**ADDENDUM NUMBER ONE
TO PLANS AND SPECIFICATIONS
FOR**

Henderson Park Pavilion 804 Old N. Market Street Brenham, Texas

August 13, 2026

A8.1

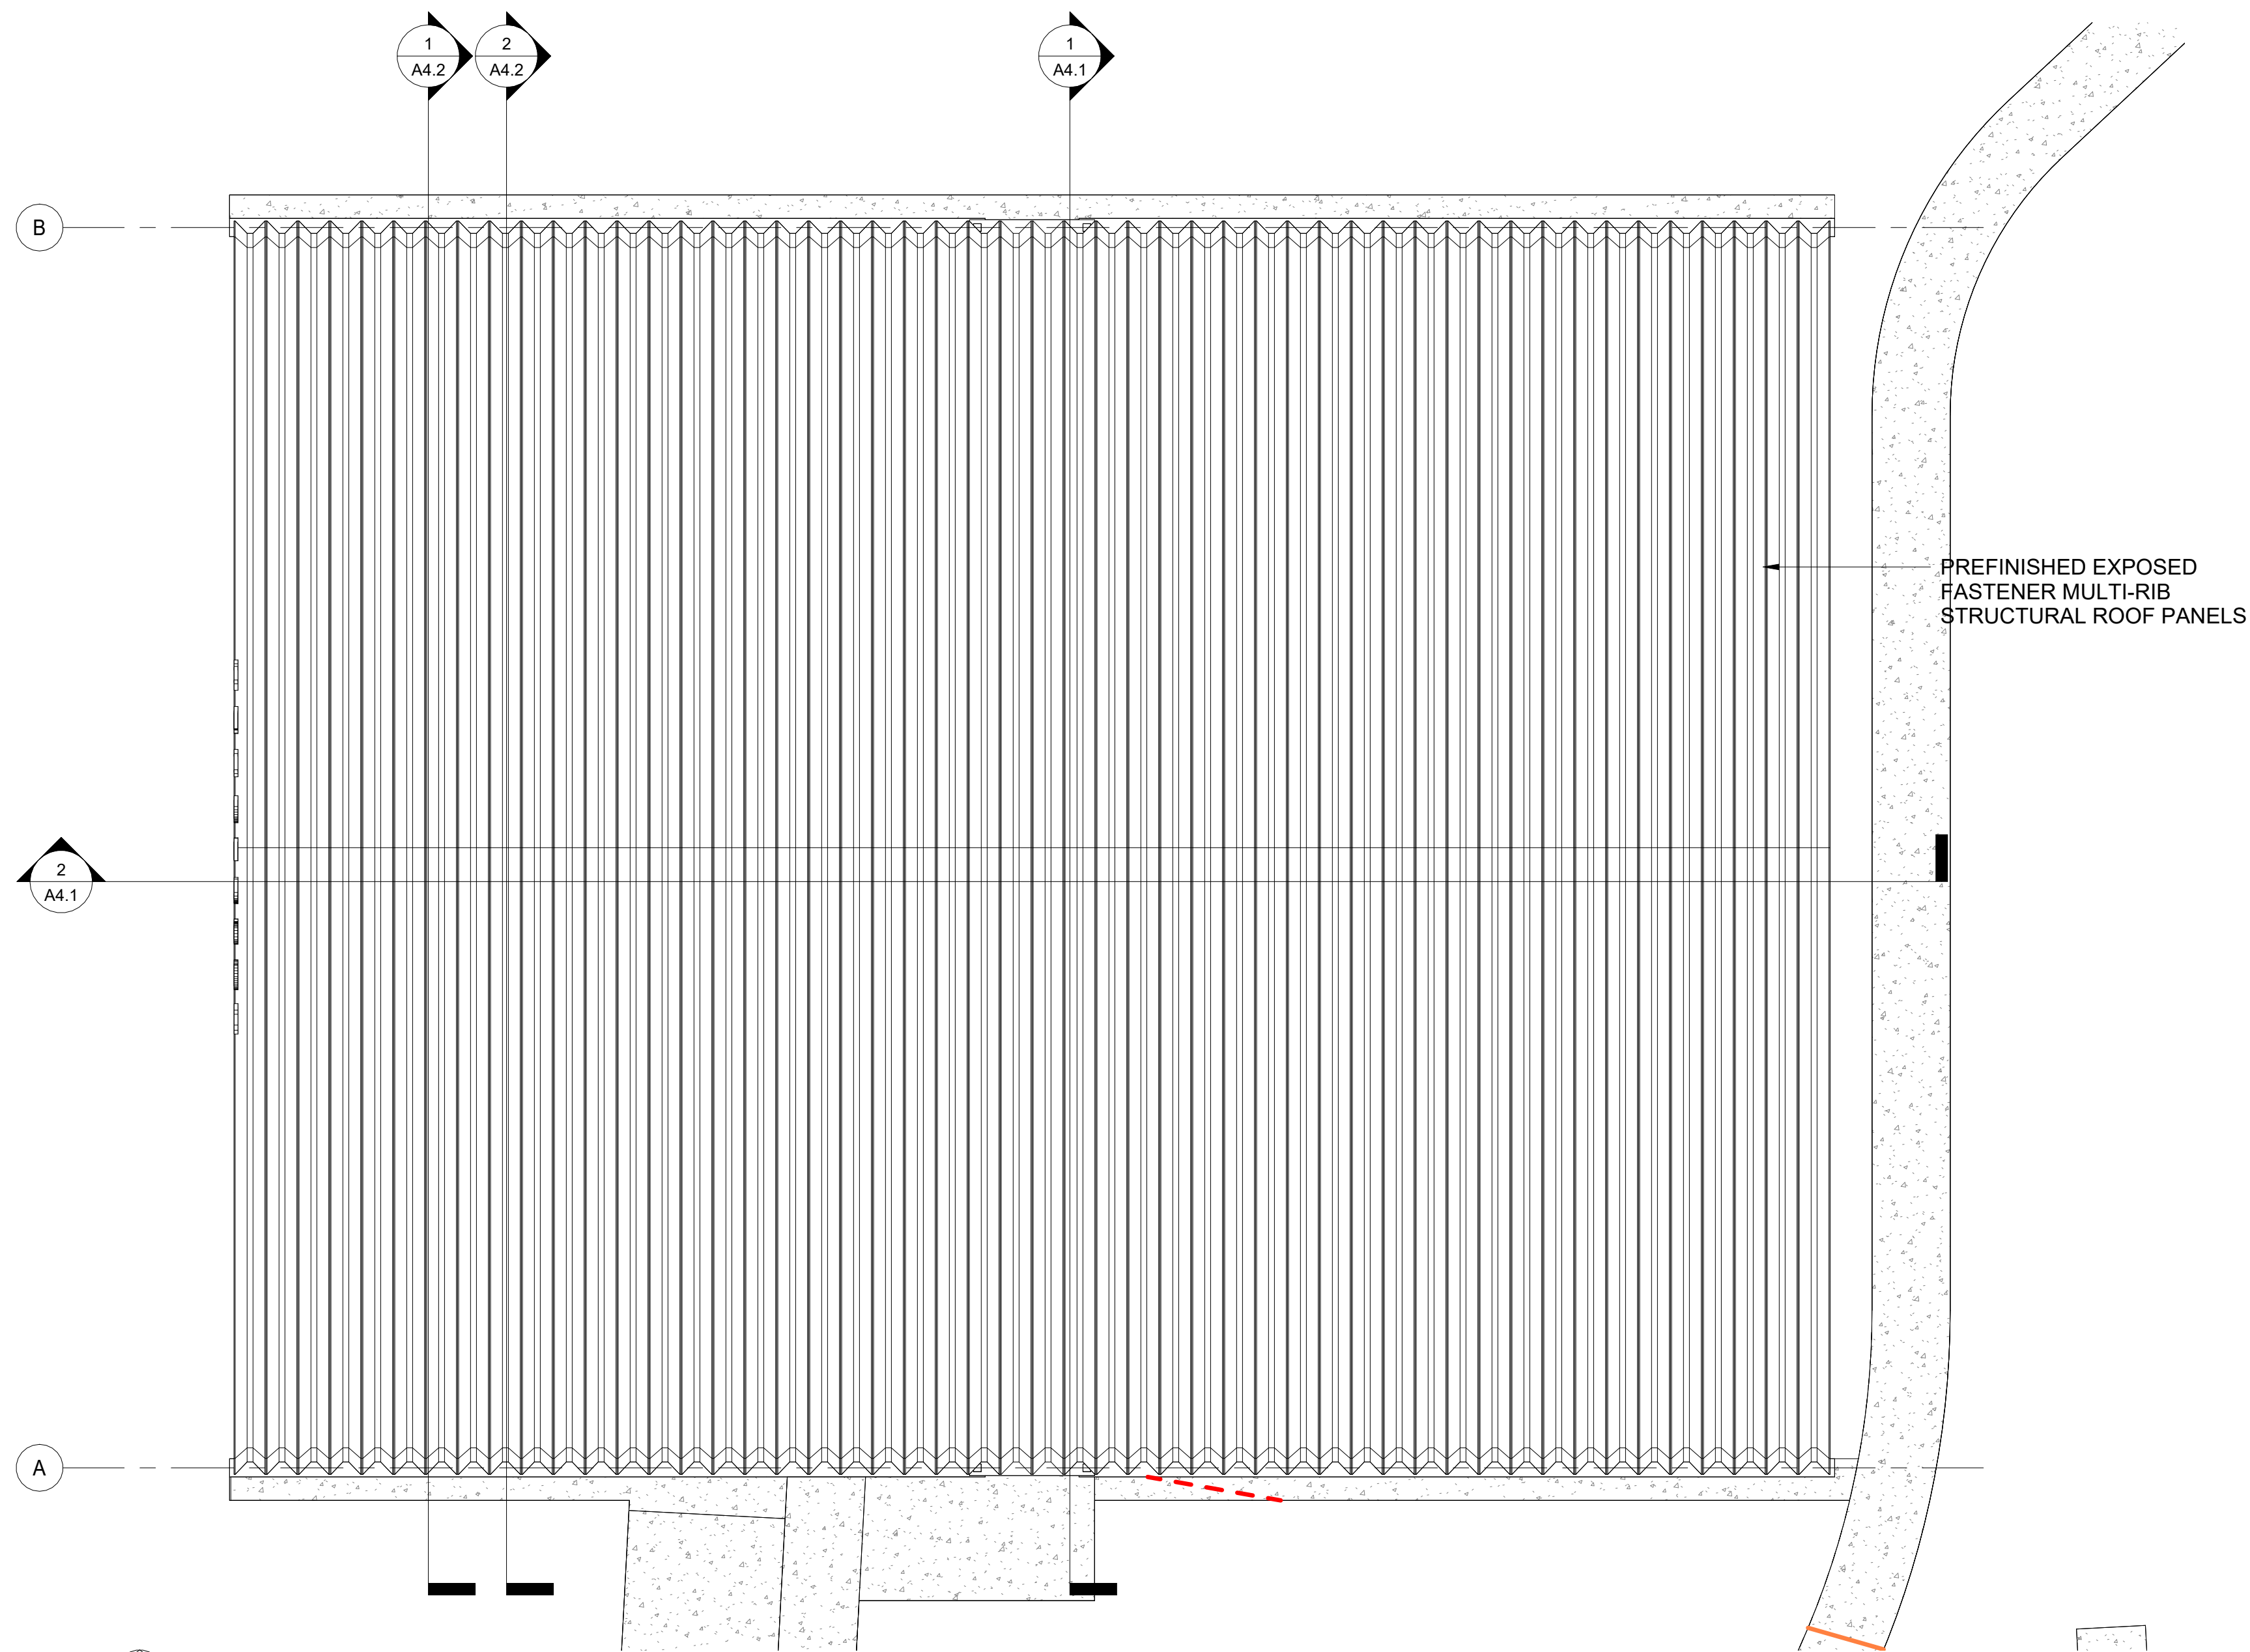
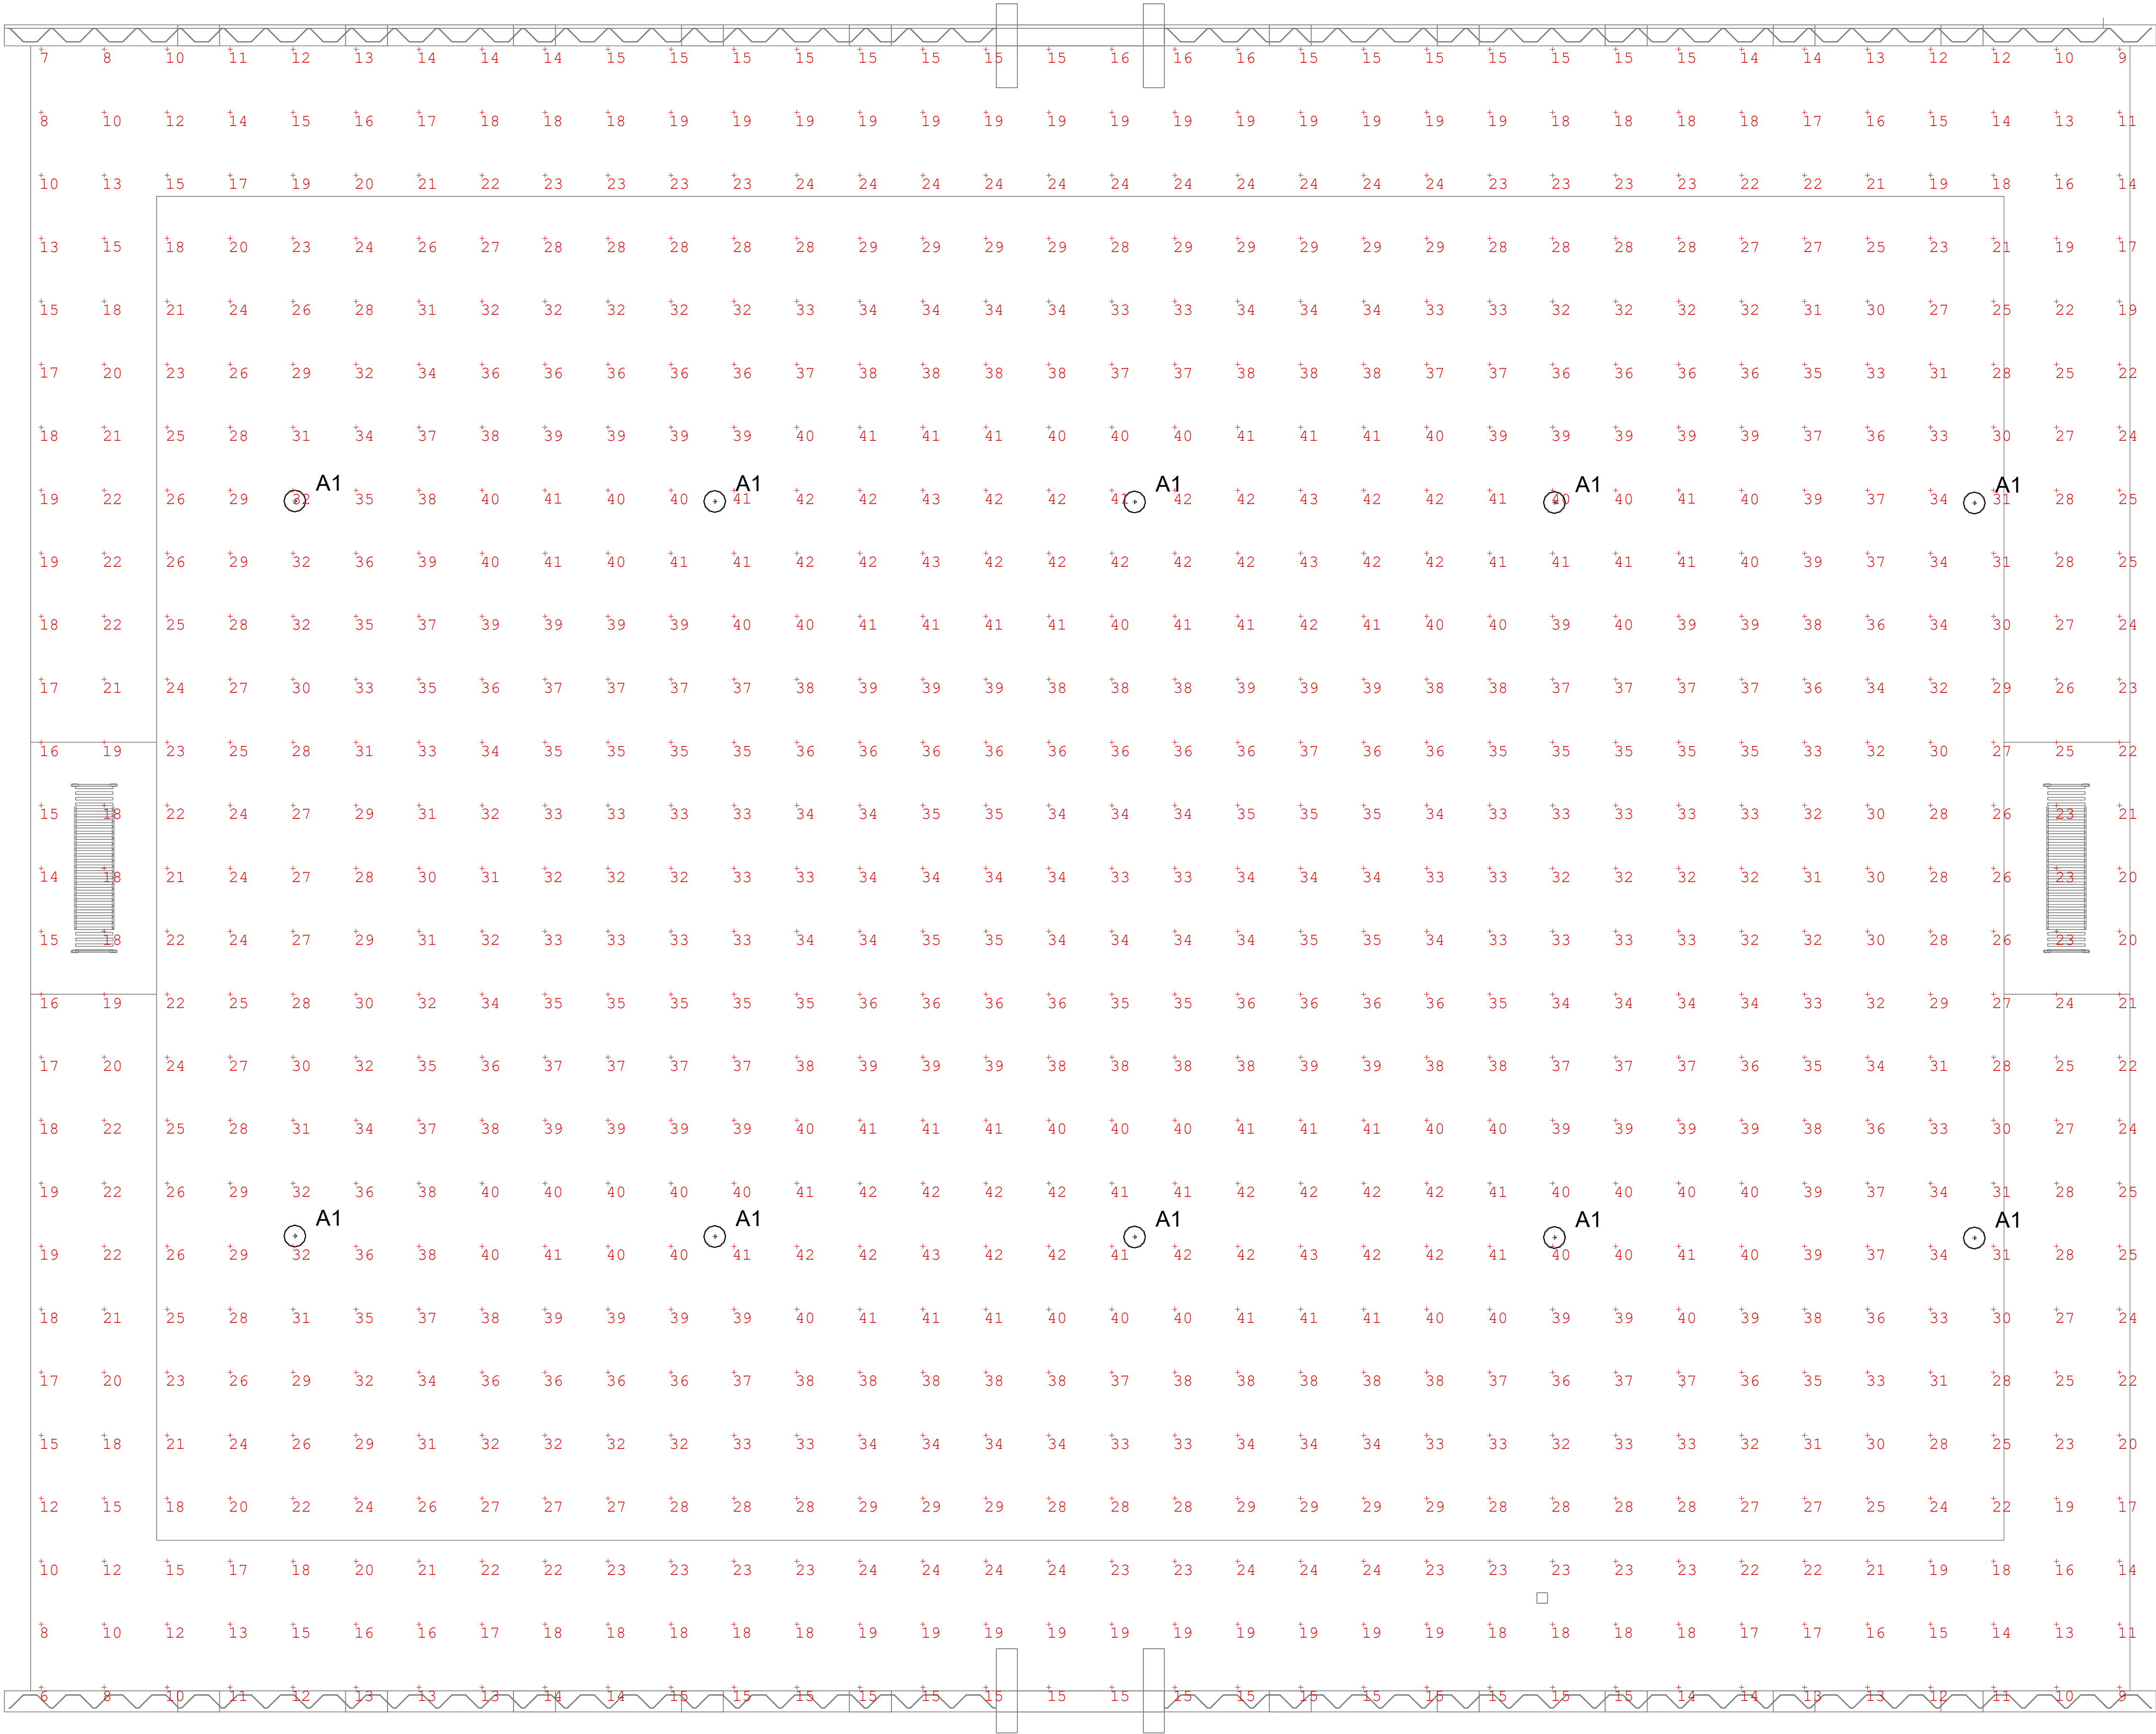
1. **CLARIFICATION:** Pendants - see attached for photometrics and fixture cut sheet for recommended fixture. A8.1 Legend has been updated to show Model number recommendation

2. **REVISION:** see A8.1 Sheet for Sealed title block.
3. **REVISION:** see drawing sheets A3.1, A4.1, A4.2 and A.8.1 for revised wording for Fan Alternate requirements and revised Architectural specifications (see attached specifications section 012300 revisions) on page 4 of Addendum 01.

LEGEND		
MARK	DESCRIPTION MARK	DESCRIPTION
		PENDANT DOWNLIGHT (DESIGN BASIS: METALUX EZBY-1830C3-MV-BLK)
